CRMC DECISION WORKSHEET

2020-07-031

**STATE OF RHODE ISLAND
COASTAL RESOURCES MANAGEMENT COUNCIL
ENGINEERING REVIEW**

SUBJ: **CRMC File No.:** A*2020-07-031
Owner: Paul & Christine Grady/ Patrick Lebeau & Meghan Rawson
Site Address: 2 & 4 Shell Road Plat: 16 Lot: 195,196
Site Town: Warren
Project: Shared residential boating facility

Drawing Title:
SHARED RESIDENTIAL DOCK
PROPOSED SITE PLAN
MLWD

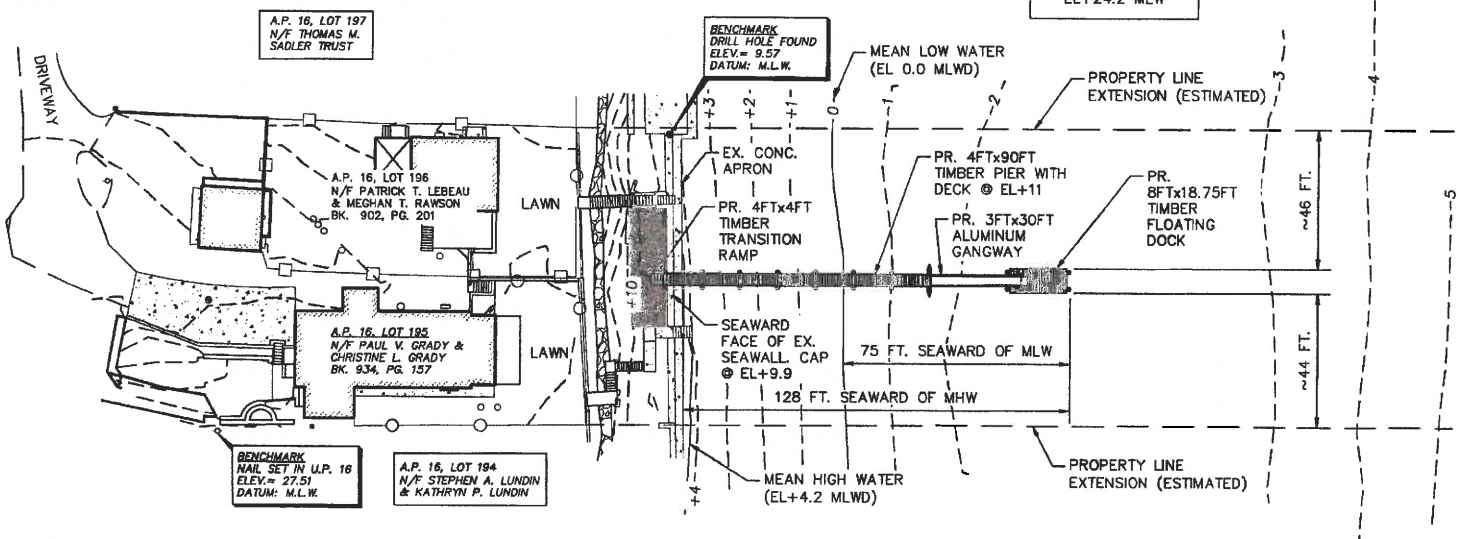
The revised Mooring Field 7 boundary is located 84.5 ft beyond mean low water. The proposed dock at 75ft beyond mean low water would not penetrate into the mooring field but would require a variance of 40.5 ft from the 50ft setback. The proposed facility does not obstruct any existing moorings. The nearest moorings are owned by the applicants and are 149ft and 218 feet from the proposed dock. In addition, all five other existing docks along the half mile stretch of the mooring field are located within the setback or intrude into the mooring field if the boundaries were not adjusted to accommodate.

Drawing Title: **SHARED RESIDENTIAL DOCK**
 PROPOSED PIER PLAN & PROFILE
 MLWD

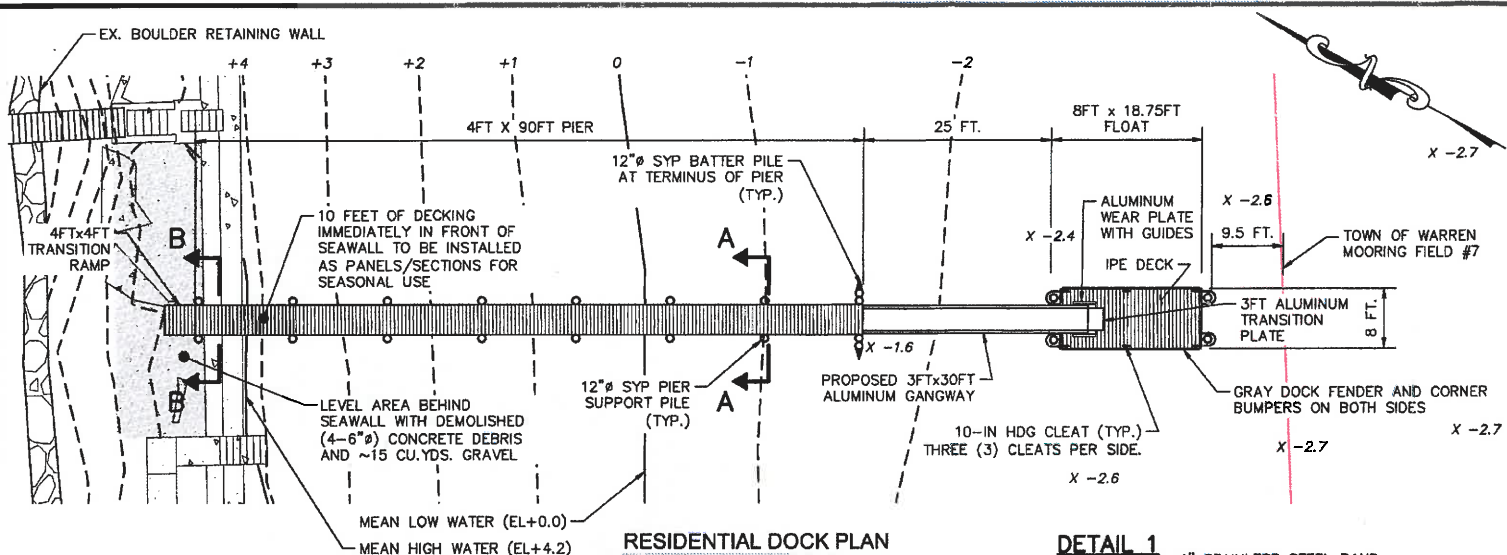
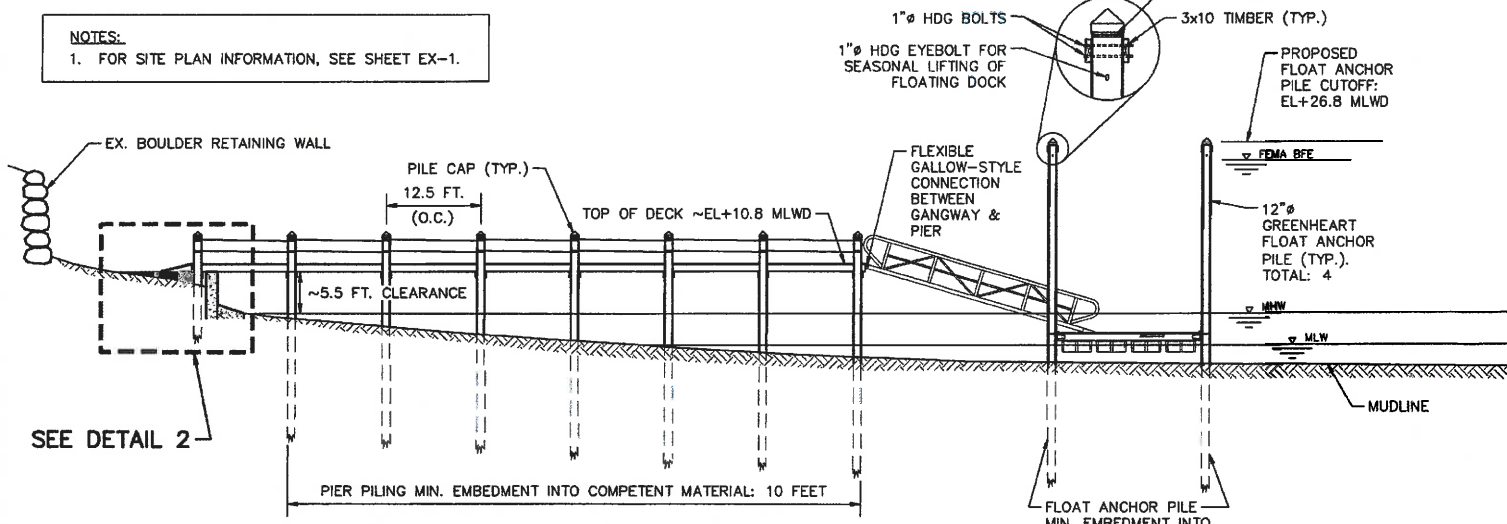
1.1.7(A)(3) states *“Due to conditions at the site in question, the applicable standard(s) cannot be met.”* If the facility were built to meet the length standard at 50 feet beyond mean low water, the water depth at the terminus would be 2.4 feet. This exceeds the minimum required water depth of 1.5 feet per Table 1.3.1.(D)(11)(z). This depth is typically used by CRMC as the standard minimum depth to accommodate reasonable use of a residential boating facility. The water depth at 75 feet beyond mean low water is 2.6 feet. The applicants state that the additional two and a half inches of water depth gained by extending the facility to 75 feet beyond mean low water would allow greater use of the facility at lower tides. By extending the dock to 75 feet past mean low water, the entire length of the terminal float would be in water over 2 feet deep. At 50 feet past mean low water, the 20 foot length of terminal float would be placed in water between 1.6 feet and 2.4 feet. The applicant has argued that the additional water depth is necessary to orient the vessel to face south against oncoming waves; the additional 5 inches of water at the landward side of the float will help prevent the engine from bottoming out on lower tides.

were shortened to the 50 foot standard, it is Staffs opinion that the water depths would not impede the intended use as a touch and go facility. At a 50 ft length the water depth of 2.4 feet exceeds the minimum standard of 1.5ft. Furthermore, at 50 feet, the residential boating facility would minimize the required variance for setback into the mooring field. While the requested variances would provide a small amount of water depth to allow for better use of the facility, it is questionable whether this is the minimum necessary.

The application requests Assent to construct a “touch-and-go” residential boating facility that requires a variance to the length standard and the mooring field setback. The facility is proposed to terminate at 75 ft past mean low water at a water depth of 2.6 feet. The proposed facility at 75 feet past mean low water is not unusually long for the area, however in light of the objection the requested variances should be more carefully considered. The requested variance only provides an additional 2½ inches of water, and at that proposed length the facility would extend within 9.5 feet of the revised mooring field. Staff defers to the Council to determine whether the applicant has met the variance criteria. In light of the objection Staff does not object to the modification of the facility if it is redesigned to the 50 feet beyond mean low water standard. Should the Council approve this application, a standard dock assent will be prepared.
